Project	IEEE 802.16 Broadband Wireless Access Working Group < http://ieee802.org/16 >	
Title	HARQ Through RS UL Dedicated Channel	
Date Submitted	2007-09-09	
Source(s)	Derek Yu, Hang Zhang, Peiying Zhu, Wen Tong, David Steer, Gamini Senarath, Mark Naden, G.Q. Wang Nortel 3500 Carling Avenue Ottawa, Ontario K2H 8E9	Voice: +1 613 763-1315 E-mail: [mailto:wentong@nortel.com] [mailto:pyzhu@nortel.com]
Re:	IEEE P802.16j/D1: IEEE 802.16j working group letter ballot #28.	
Abstract	The current baseline does not specify how to support HARQ for the RS UL_DCH. The RS UL_DCH supports signaling and data traffic associated with service flows, and hence HARQ needs to be supported. The sub-burst IE used for HARQ is not applicable to the RS UL_DCH. This contribution supplies text to support HARQ for the RS UL_DCH.	
Purpose	To incorporate the proposed text into the P802.16j Baseline Document IEEE P802.16j/D1 (August 2007).

HARQ Through RS UL Dedicated Channel

Figure XXX – UL DCH control header

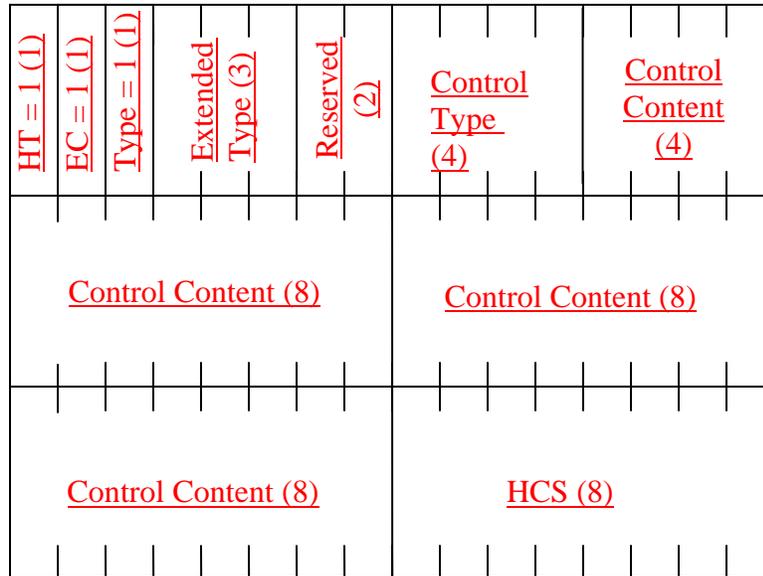
6.3.2.1.2.2.2.7 UL DCH control header

The UL DCH control header is used by the RS to send control signaling to MR-BS or parent RS. The header format is as follows:

Table XXX - UL DCH control header format

Syntax	Size	Notes
MAC Header(){		
HT	1 bit	Shall be set to 1
EC	1 bit	Shall be set to 1
Type	1 bit	Shall be set to 1
Extended TYPE	3 bits	Shall be set to 110 for UL DCH control header
Reserved	2 bits	
Control Type	4 bits	0000 = UL DCH HARQ control 0001-1111 = Reserved
Control Content	28 bits	
HCS	8 bits	Header check sequence
}
